Staff Summary Report

Development Review Commission Date: 02/22/2011

SUBJECT: A request for a Development Plan Review for **DUTCH BROTHERS COFFEE** located at 6461 South Rural Road.

DPR11017 – Development Plan Review including site plan, building elevations and landscape plan.

EXTERIOR ELEVATIONS

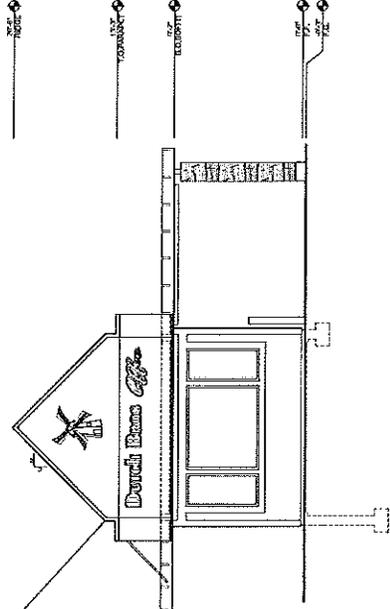
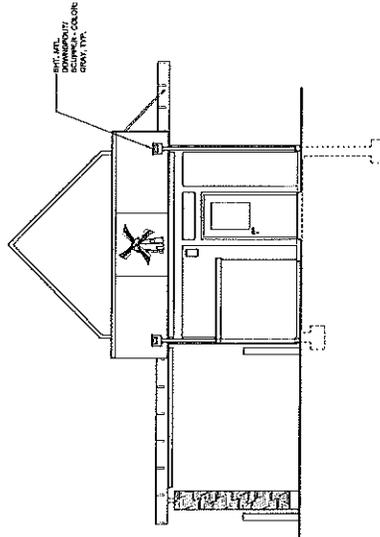
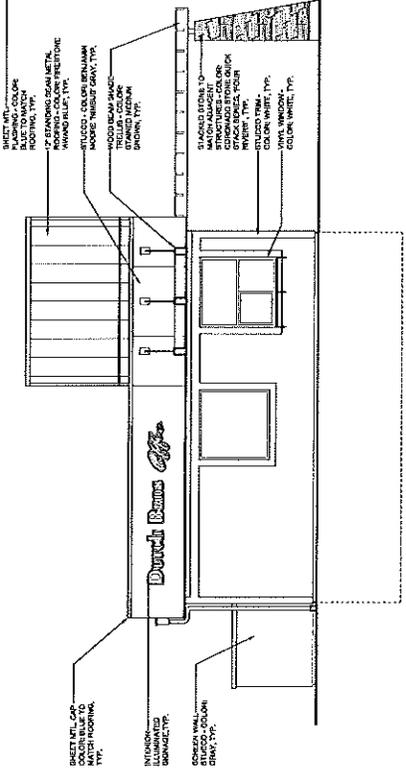
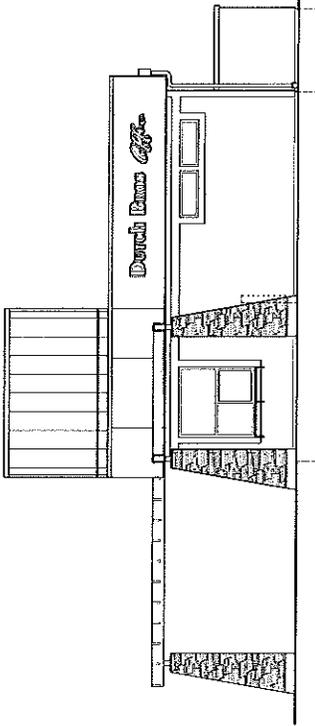
4. The color scheme and materials modified and approved for the following:
Main building stucco color - Benjamin Moore, "Shelburne Buff" #HC-28 or similar color to match
Wood Beam Shade Trellis and Drive Canopy- EIFS -Medium Brown
Standing seam metal roof-Firestone Metal Roofing- "Award Blue"
Canopy Columns- Southern LedgeStone- Cultured Stone ICC 5749 or comparable color and appearance by another manufacturer

Except that main colors and materials that exceed light reflectance value of 75 percent shall be revised to be not greater than 75 percent. Submit any additions or modifications for review during building plan check process. Planning inspection staff will field verify colors and materials during the construction phase.

5. Provide an popped out/offset stucco building base, similar in design of the shopping center building base, in a color to match Benjamin Moore "Alexandria Beige #HC-77.

6. Provide secure roof access from the interior of the building. Do not expose roof access to public view.
7. Conceal roof drainage system within the interior of the building. Minimize visible, external features, such as overflows, and where needed design these to enhance the architecture of the building.

Landscape Plan

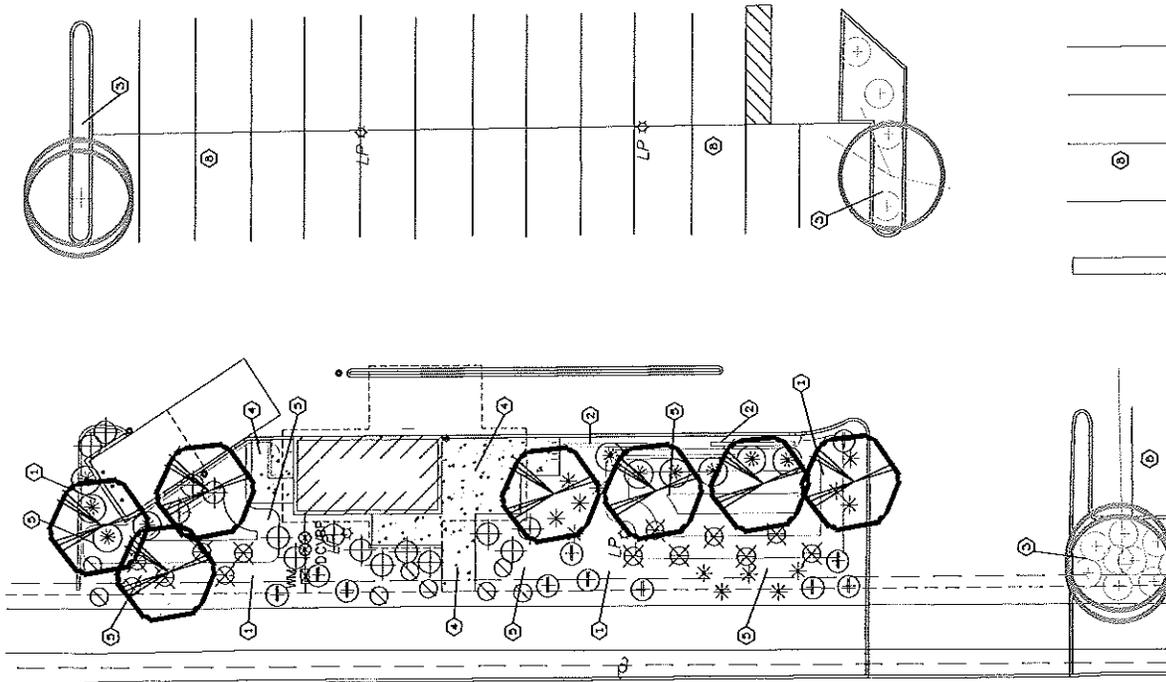
12. The preliminary landscape palette approved for the following:

All existing shrubs and ground cover are to remain. Any existing plants that fail to thrive shall be replaced with the appropriate plant from the above list.

15. Top dress planting areas with a rock or decomposed granite application. Provide rock or decomposed granite of 2" uniform thickness or less. Provide pre-emergence weed control application and do not underlay rock or decomposed granite application with plastic.
